**Re: 100% Final Technical Execution Plan for the Allied Ready Mix Bank Management Areas
Former DuPont Waynesboro Plant, Area of Concern 4
Waynesboro, Virginia
EPA ID# VAD003114832**

**Technical Execution Plan
Allied Ready Mix Property Bank Management Areas
Area of Concern 4, Former DuPont Waynesboro Site, Waynesboro, Virginia**

DOCUMENT (DATE): 90% Draft Technical Execution Plan (TEP) – Allied Ready Mix (ARM) Property Bank Management Areas (BMAs)
PRINCIPAL AUTHOR (Name, Company): AECOM for E.I. du Pont de Nemours and Company
HDR Contract No.: EP2060743

EXCAVATION
CROSS SECTIONS

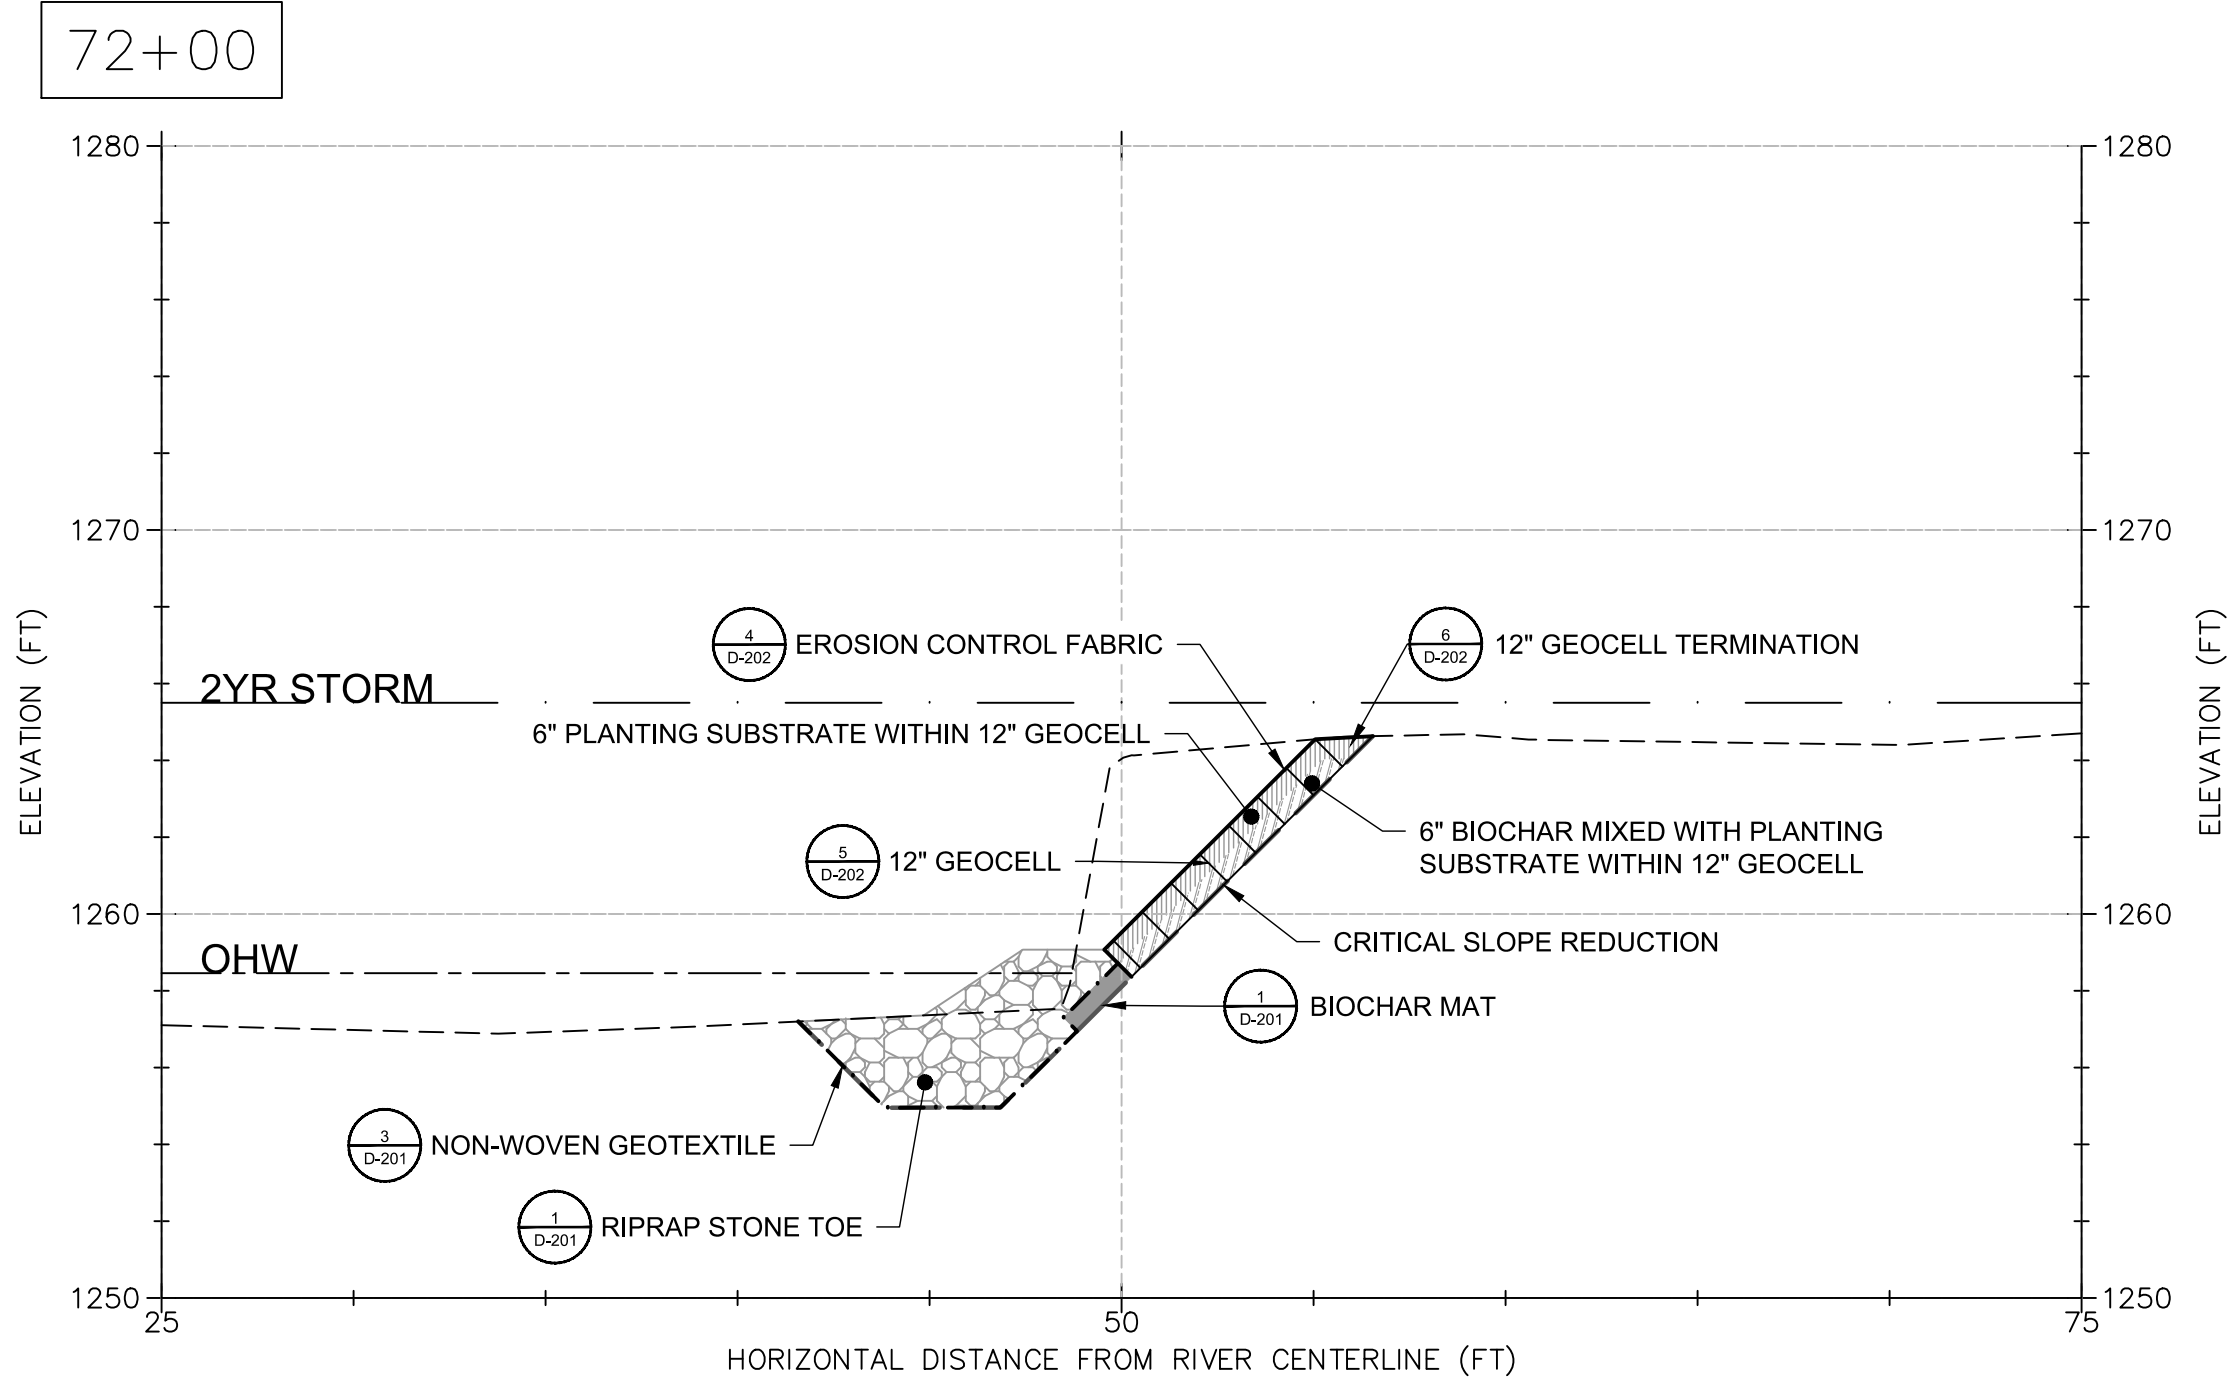
10	Sheet X-101, 102	Label other excavated slopes as 1.5:1 or add note that all slopes shall be 1.5:1 unless otherwise noted.	The cross-sections have been revised to include labels indicating bank slopes.	
11	Sheet X-103	I like the idea of having a critical slope stabilization measure for use in the field.	Agreed; critical slope stabilization treatments will add to future stabilization projects with overly steep bank angles.	
12	Sheet D-201	Add note to Geotextile Installation Detail that states all excess geotextile shall be wrapped under other material, buried, or trimmed from sight where adequately covered.	The suggested note has been added to the Geotextile Installation Detail.	
13	Sheet D-201	Detail 2, which is the typical for a Primary BMA is to have a 2:1 slope accordingly to page 10 in the text. Revise to 2:1.	Detail 2 has been revised accordingly.	
14	Sheet D-201	The geocell at the bottom of the slope appears to butt up against the top of the stone toe, instead of being installed under the stone toe as was performed at the City Shops.	Details 1 and 2 have been revised to state that where geocell meets riprap, a minimum of two rows of geocell shall be buried under riprap stone toe, per manufacturer recommendations.
